# ALERT SERVICE BULLETIN

ASB NO. 94046 REV. E • DATE: DECEMBER 4, 1996 • PAGE 1 OF 10

**SUBJECT:** **CROSSTUBE ASSEMBLY;**  
P/N 206-323-all dash numbers (High Skid and Lightweight Float Crosstubes), P/N 206-325-all dash numbers (Low Skid Crosstubes), and P/N 206-328-all dash numbers (Pan Style Float Crosstubes), **INSPECTION AND OR MODIFICATION OF.**

**HELICOPTERS AFFECTED:** All Bell 206L, L-1, L-3, L-4 model helicopters equipped with subject crosstubes.

FIGURE 1

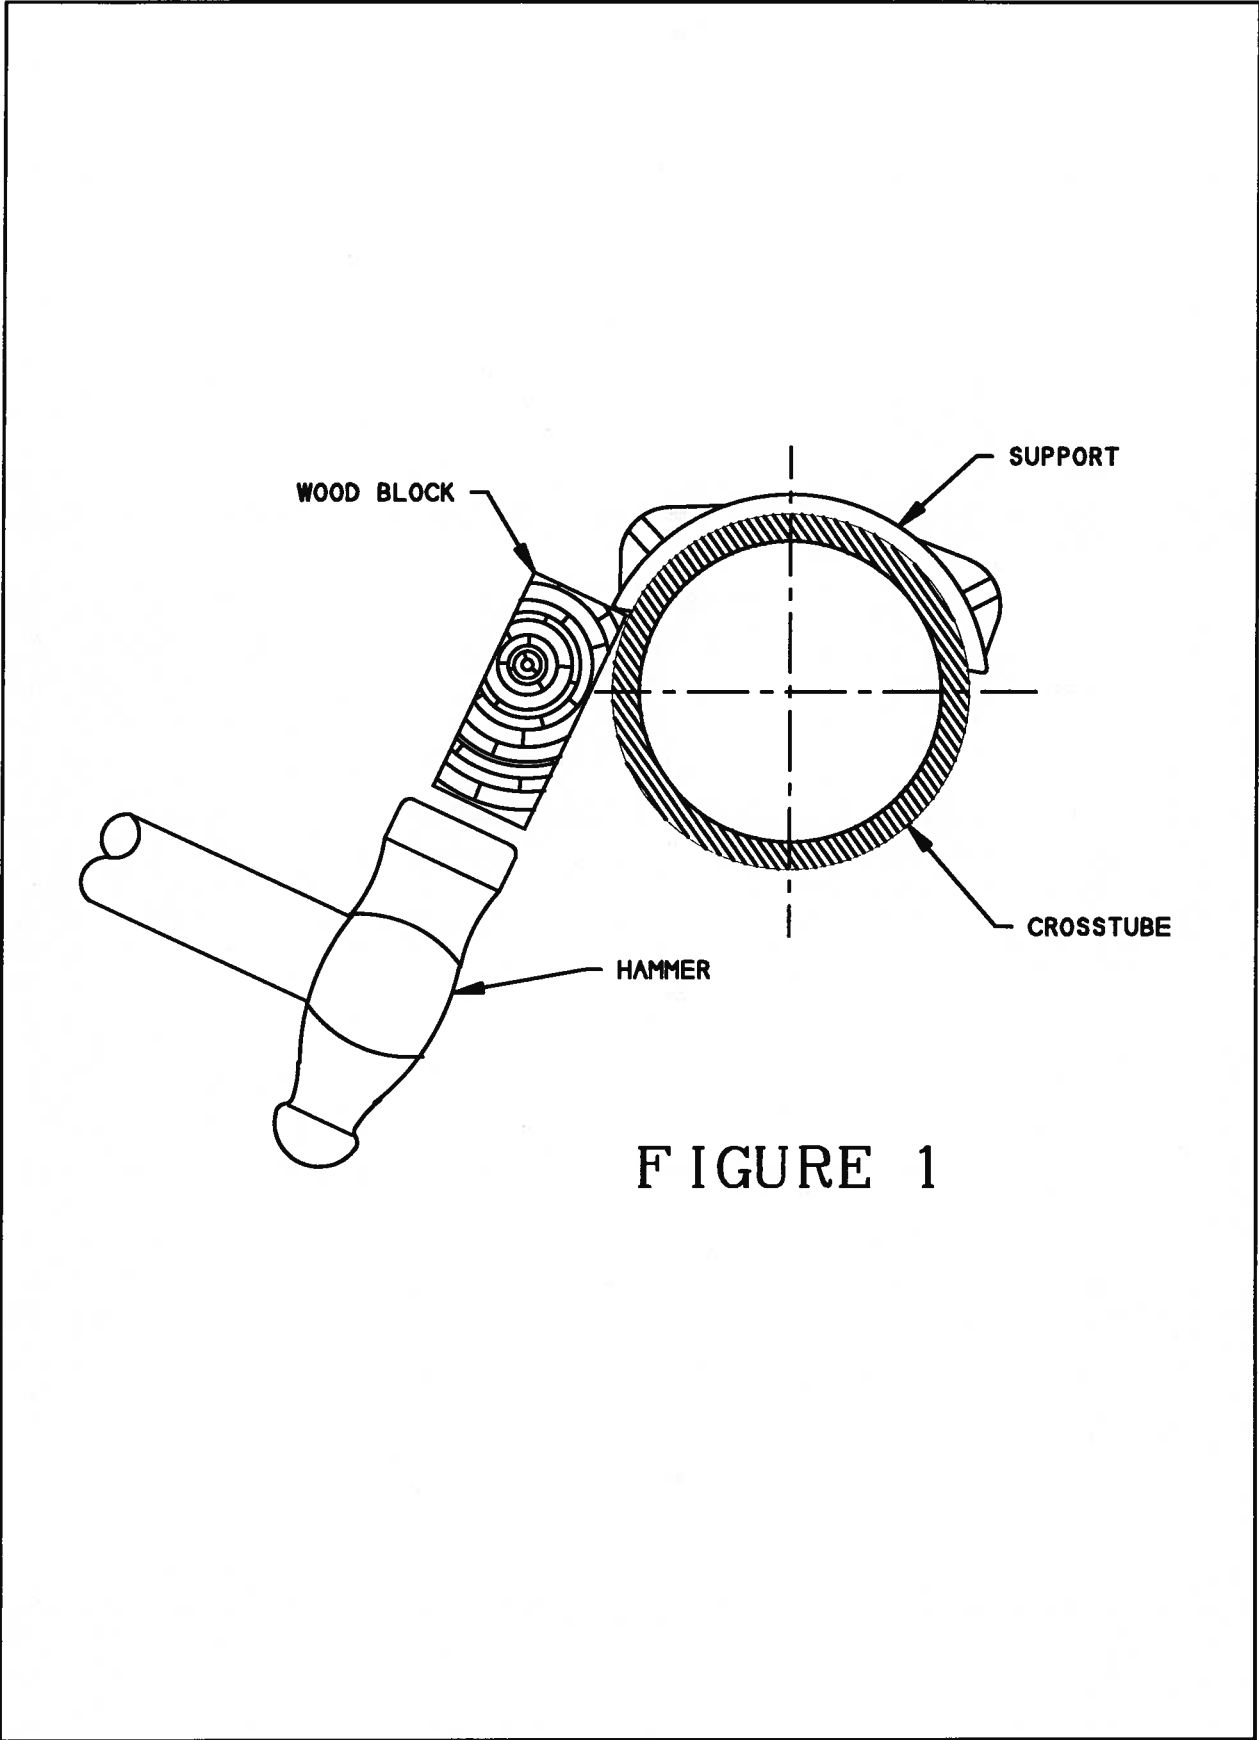
7. Use a Heat Gun to heat the Support/Sealant and remove the Clamp-On-Support. If necessary use a block of wood and hammer to strike the Support abutment in an upward motion to remove Support as shown in Figure 1. **CAUTION:** Support could be hot!

FIGURE 2

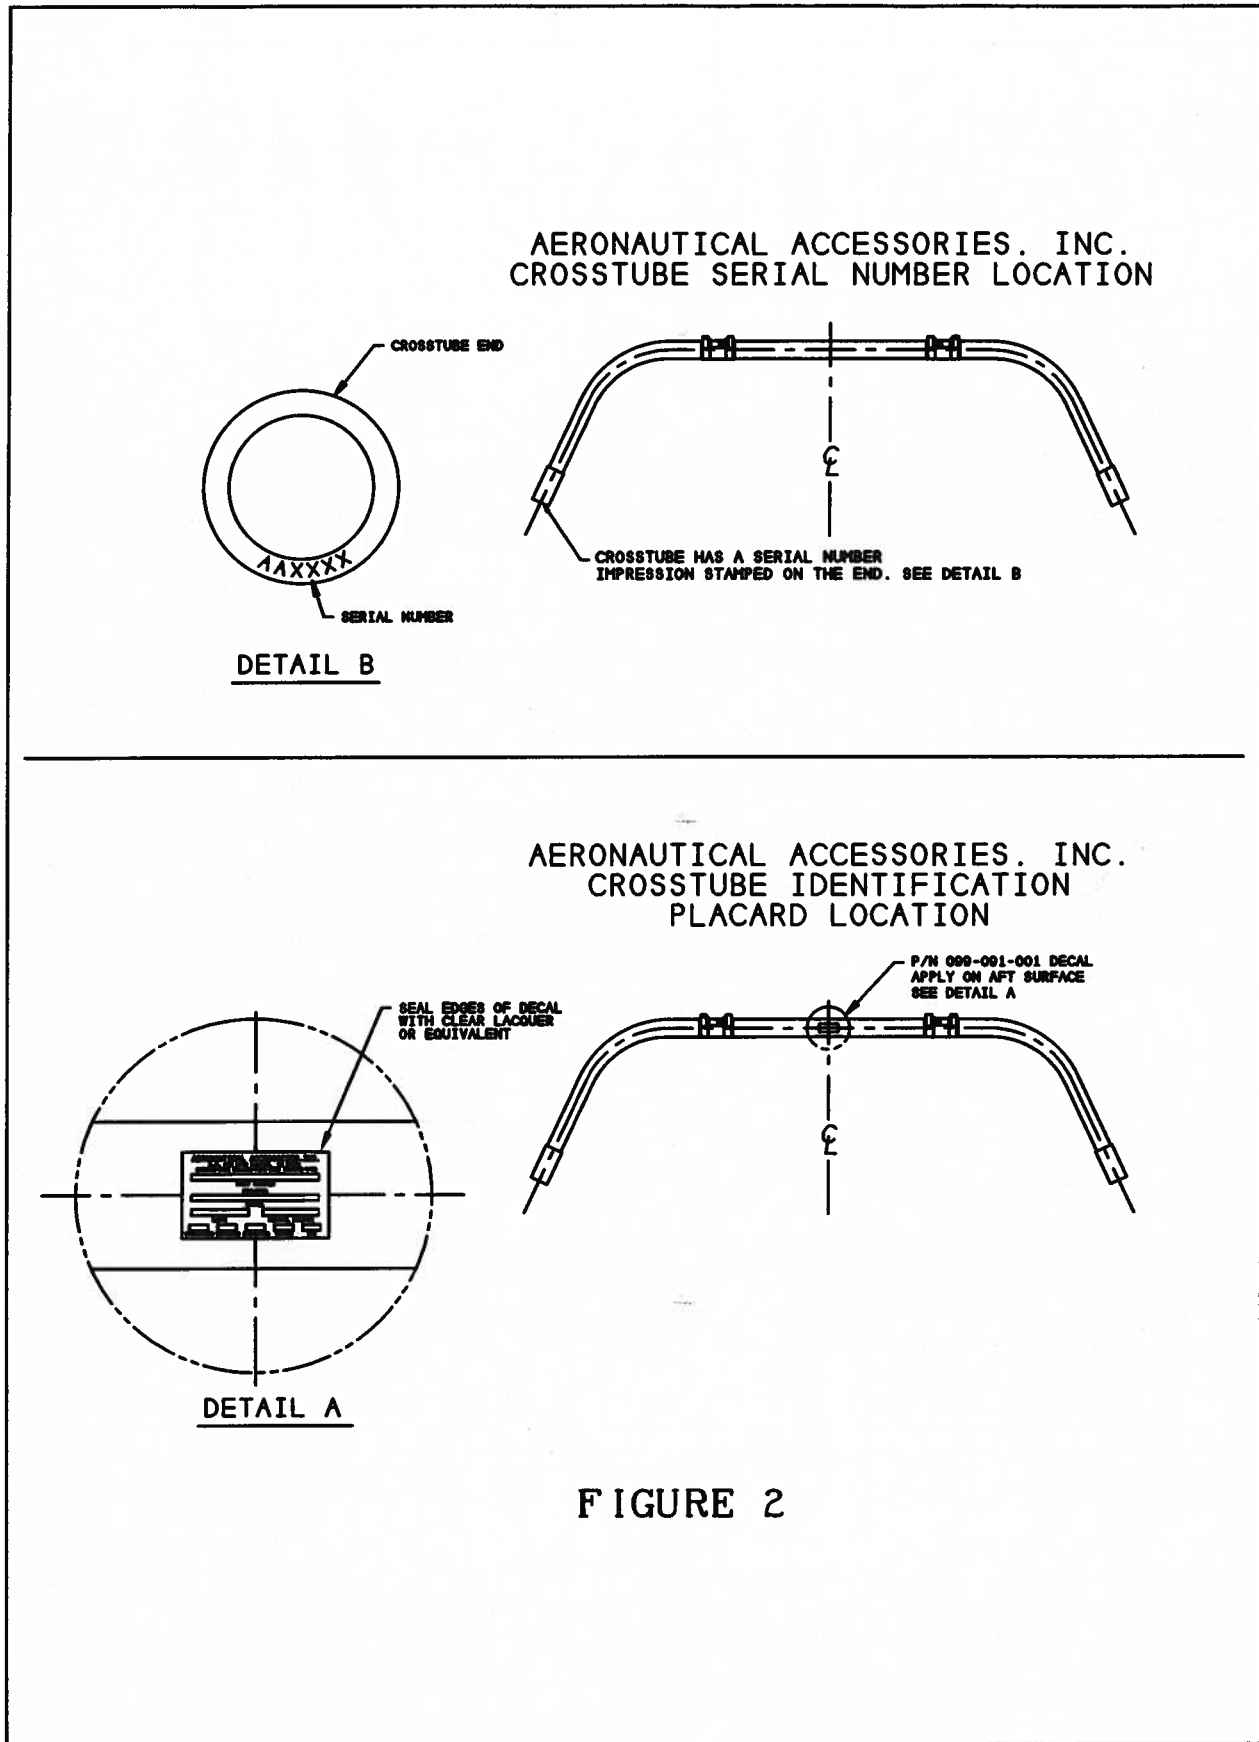
To facilitate the identification of Aeronautical Accessories Inc. crosstubes, please see Figure 2 Detail B, showing serial number location.

Once Aeronautical Accessories Inc. crosstubes are identified, record the serial number(s) and return a list of these numbers to Aeronautical Accessories Inc. We will forward serialized labels to affix, per figure 2 Detail A, to your crosstubes for ease of identification. Aeronautical Accessories, Inc. will add "-M" to the crosstube part number to indicate that this ASB has been complied with.
